Limerick Generating Station, Units 1 and 2
Facility Operating License Nos. NPF-39 and NPF-85
NRC Docket Nos. 50-352 and 50-353

Subject: Response to Request for Additional Information Concerning Relief
Requests Associated with the Second Inservice Inspection (ISI) Interval

**Response to Request for Additional Information
Regarding Relief Requests Associated With the
Second Inservice Inspection Interval**

Limerick Generating Station, Units 1 and 2

N4 Feedwater

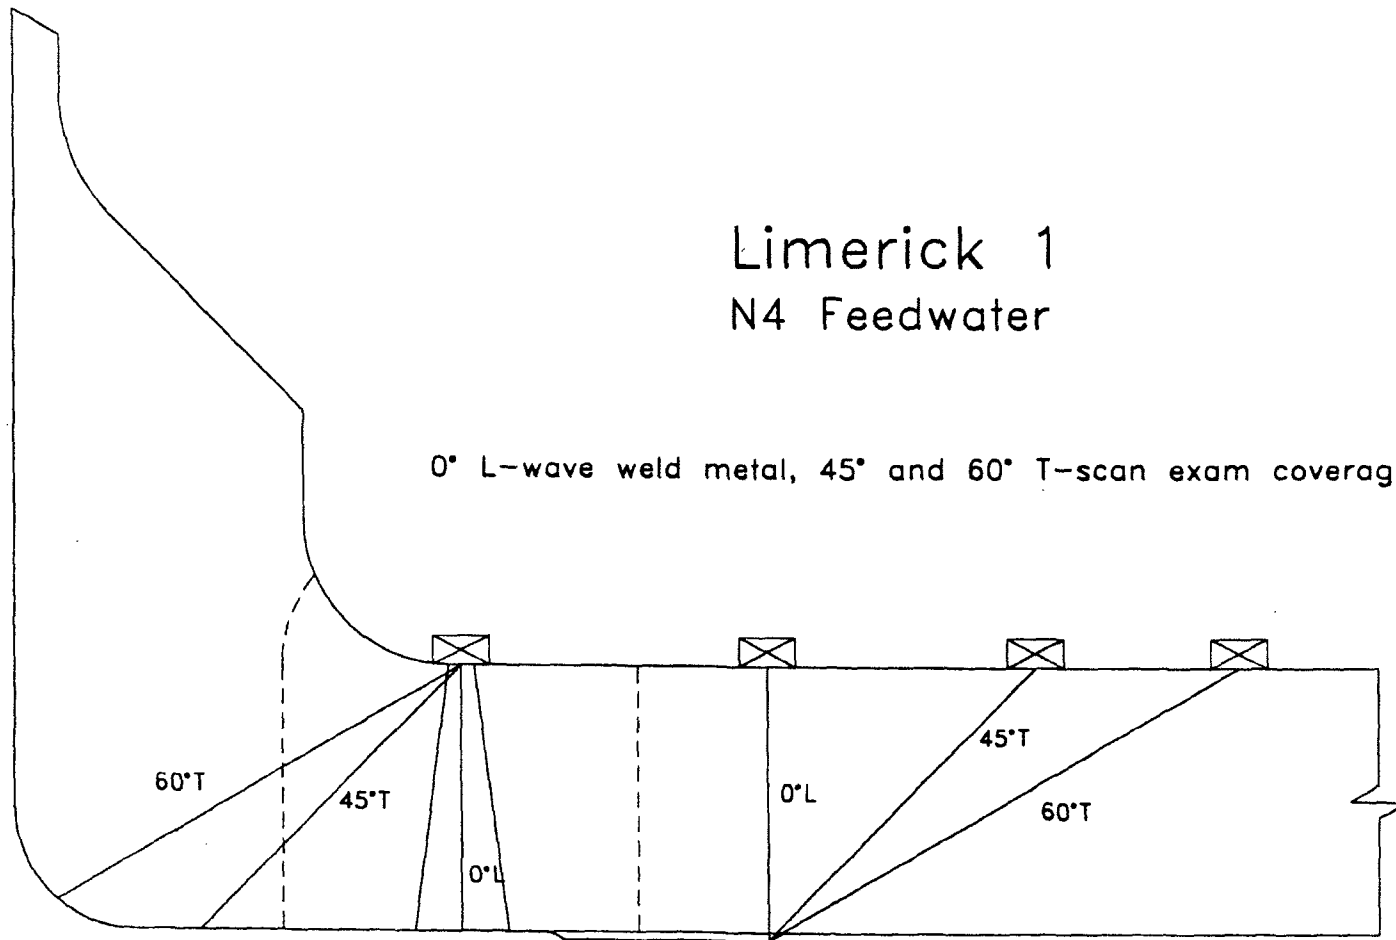
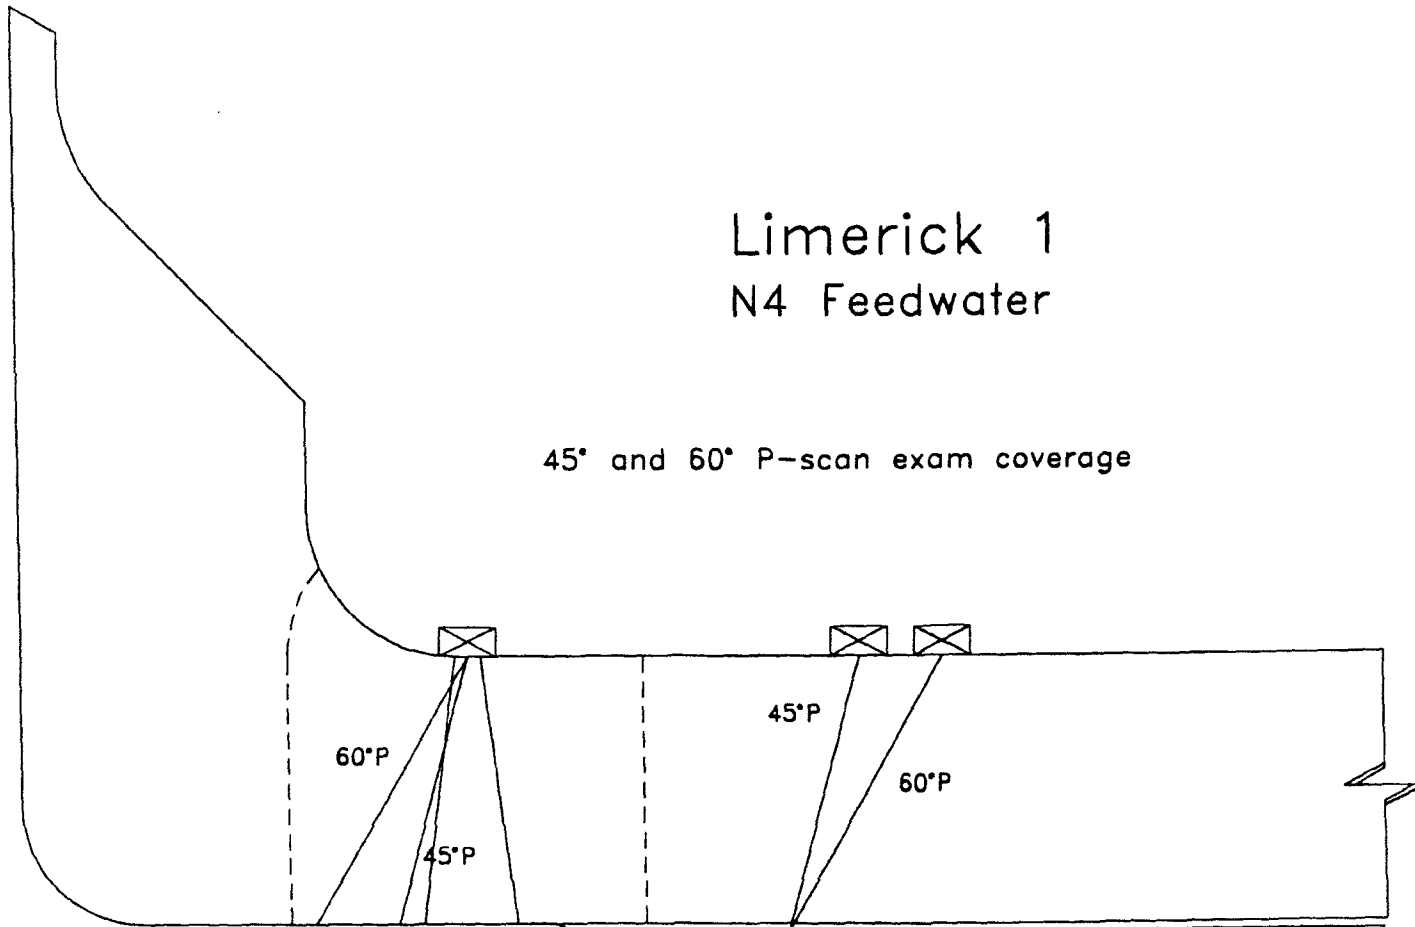
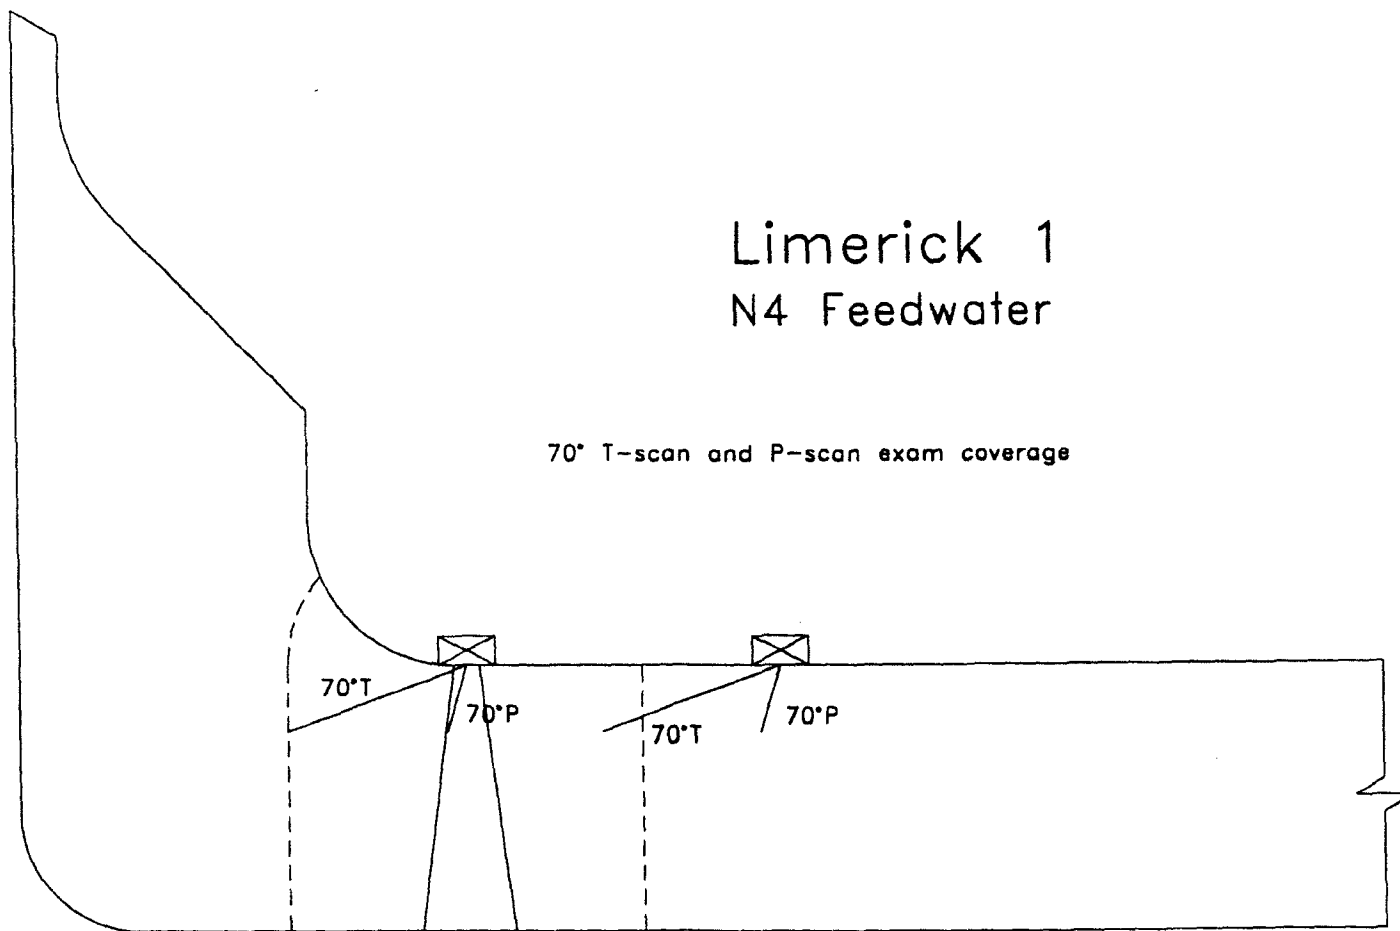
The completed examination was limited to 55.9% Code required coverage due to the design of the reactor vessel nozzle and the location of the N11B nozzle. The following coverage calculation sheet and the drawings contain the limitations. No unacceptable indications were noted. A system pressure test was also completed with no unacceptable indications observed.

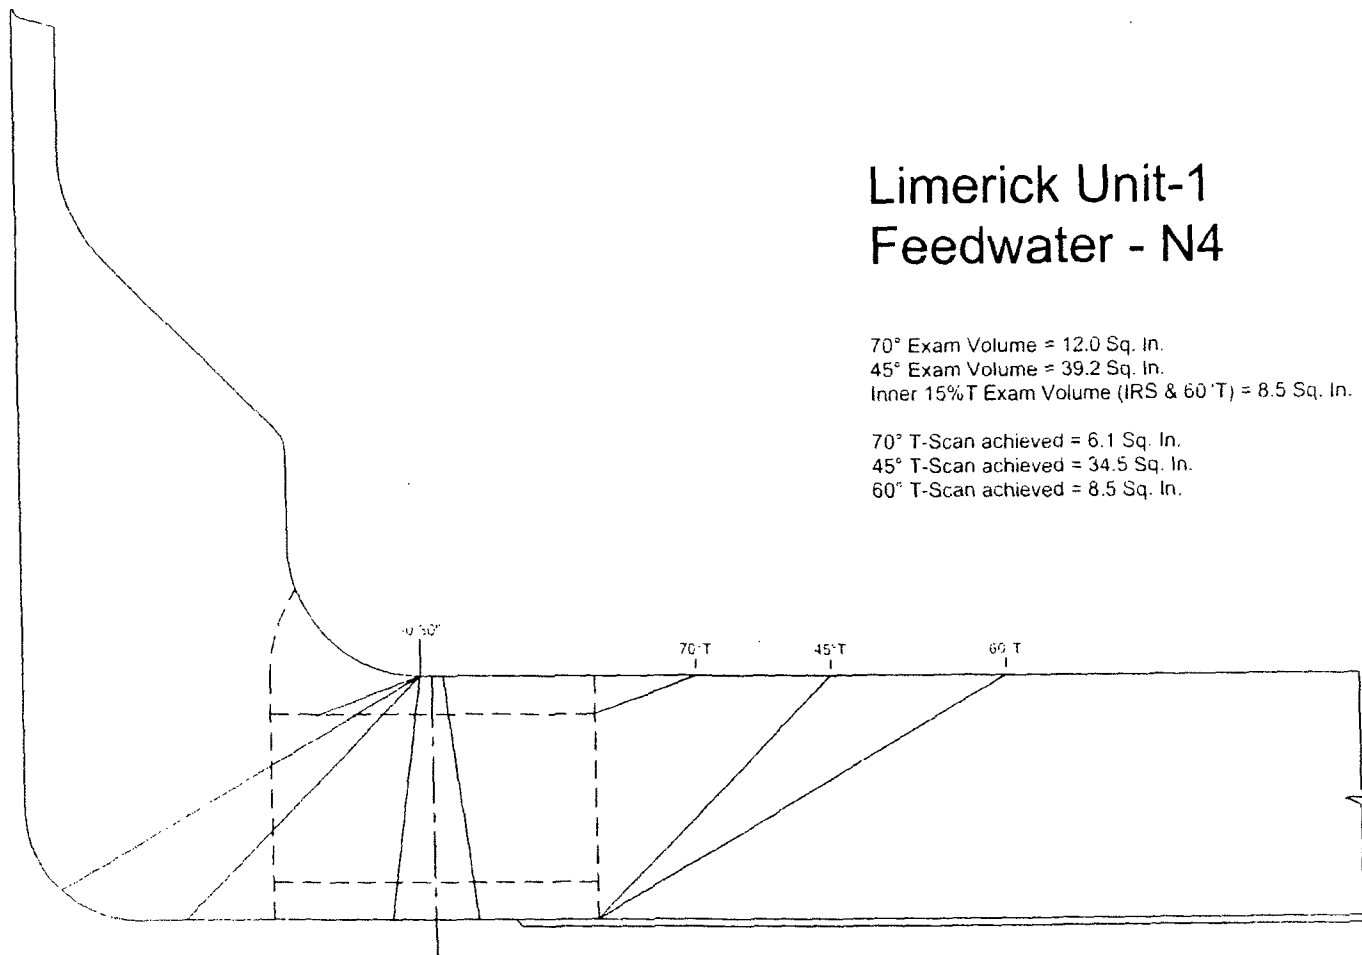
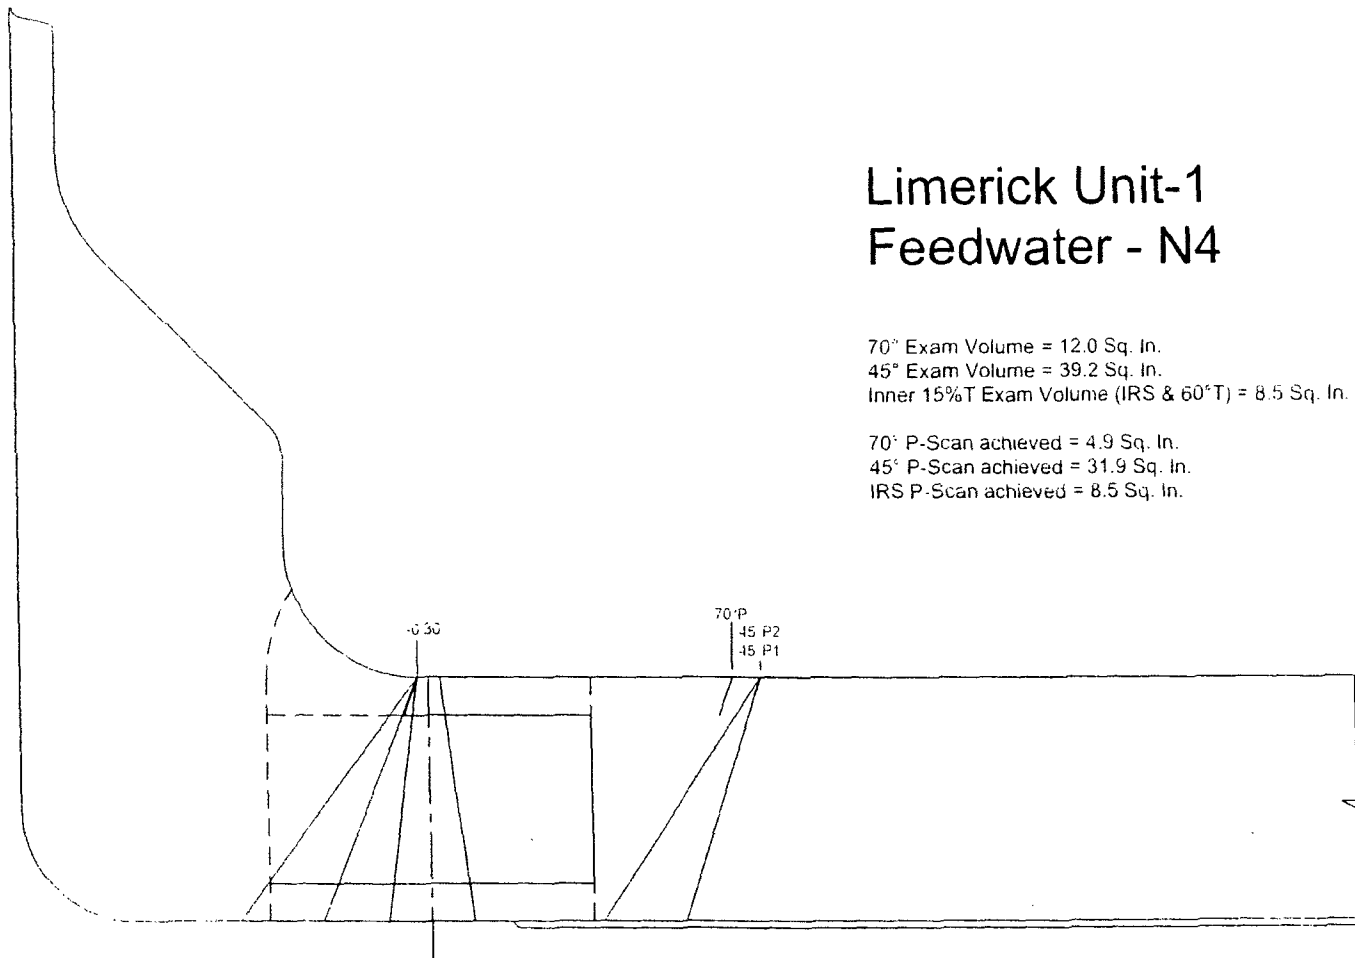
The completed examination was limited to 79.1% Code required coverage due to the design of the reactor vessel nozzle. The following coverage calculation sheet and the drawings contain the limitations. No unacceptable indications were noted. A system pressure test was also completed with no unacceptable indications observed.

Comments: A - Scanned 360 deg., Scanning limited due to nozzle configuration.

Limerick Unit-1 Feedwater - N4

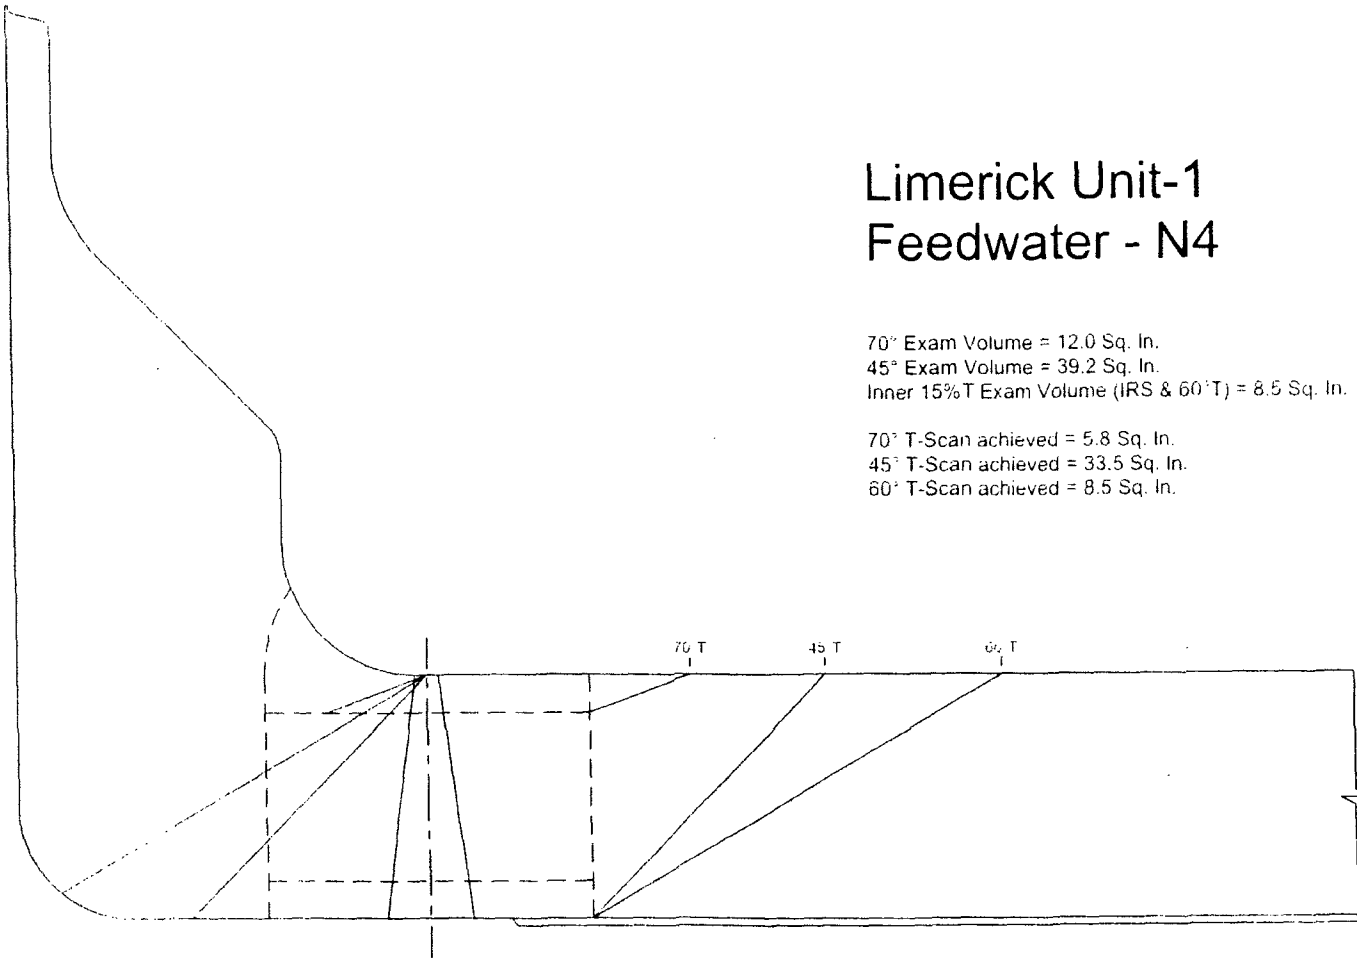
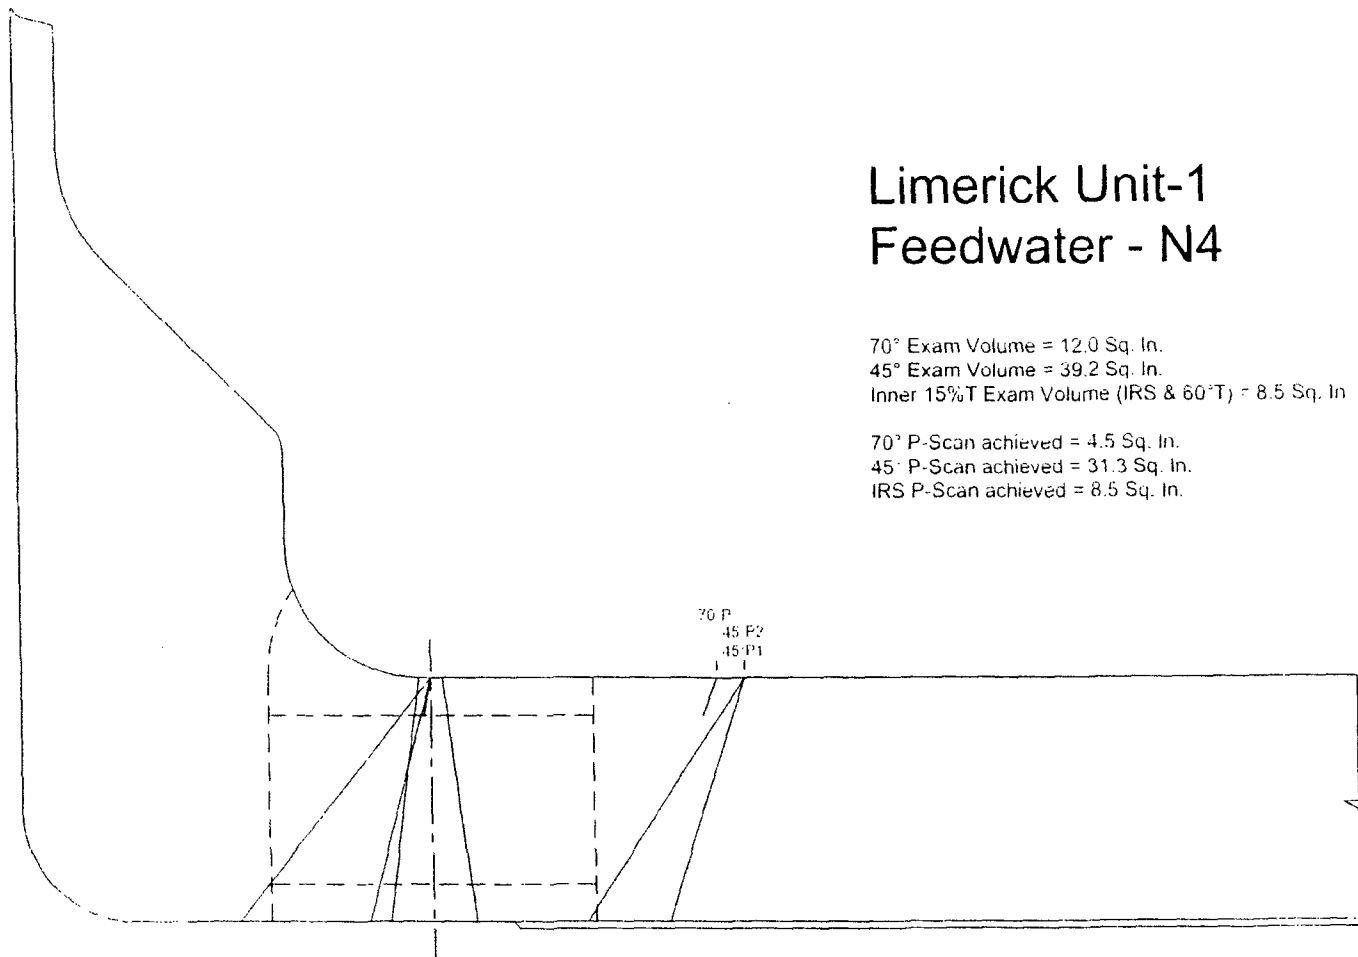
The completed examination was limited to 77.1% Code required coverage due to the design of the reactor vessel nozzle. The following coverage calculation sheet and the drawings contain the limitations. No unacceptable indications were noted. A system pressure test was also completed with no unacceptable indications observed.

Comments: A - Scanned 360 deg., Scanning limited due to nozzle configuration.

Unit 1 Vessel Nozzle and Weld Locations

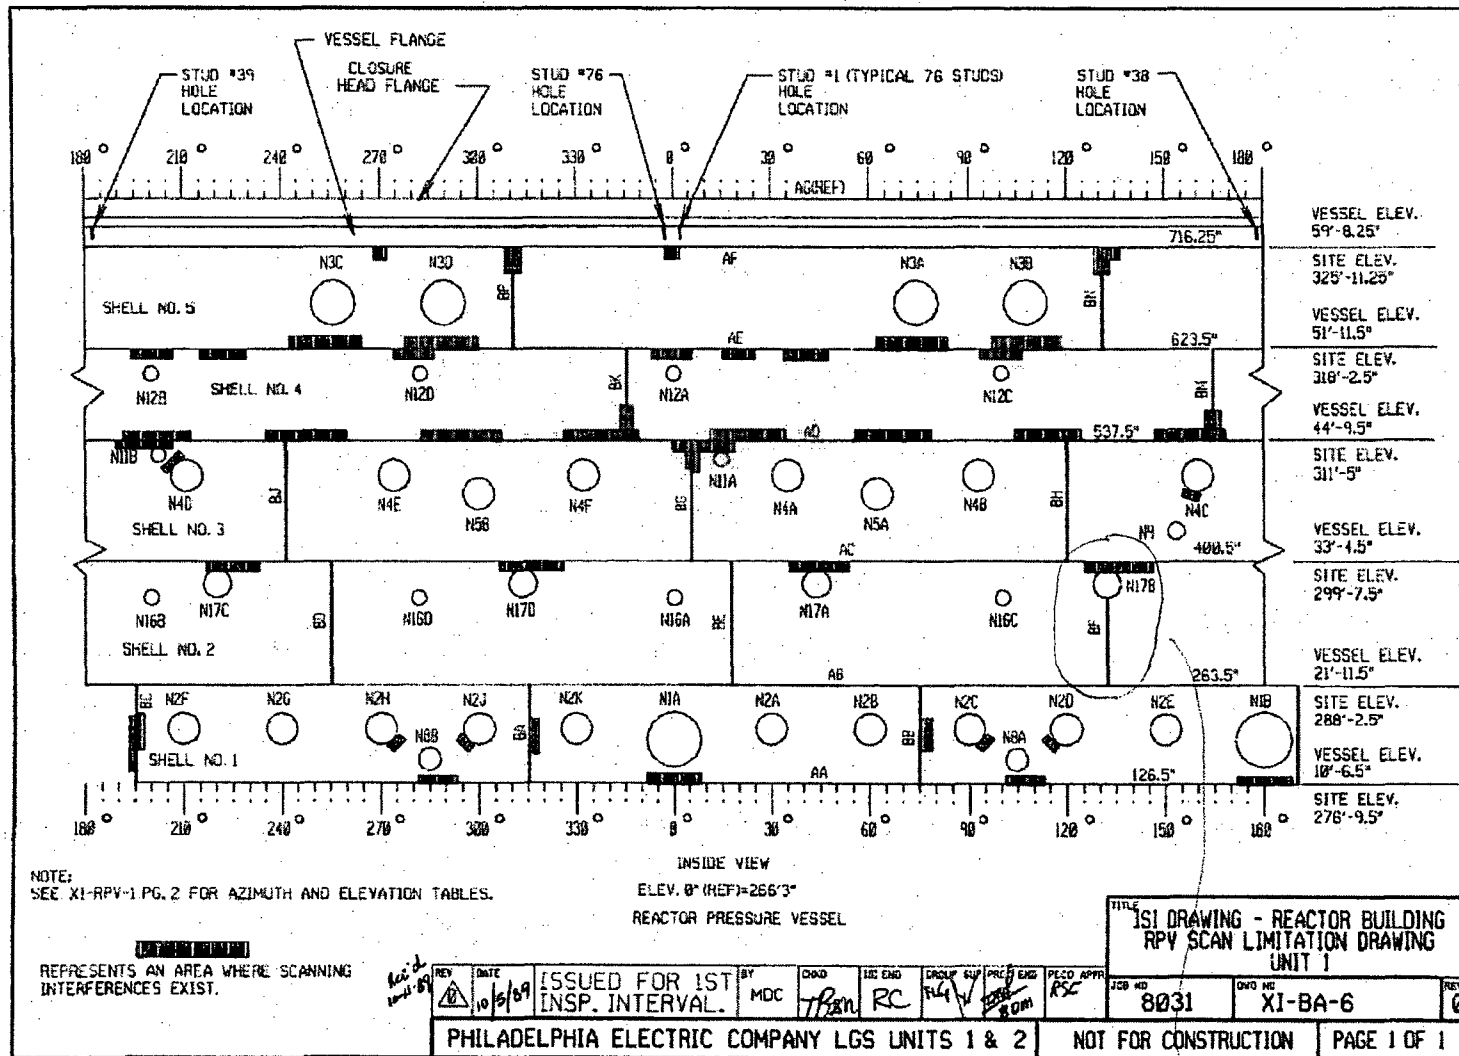
BF weld is limited
due to N17B nozzle
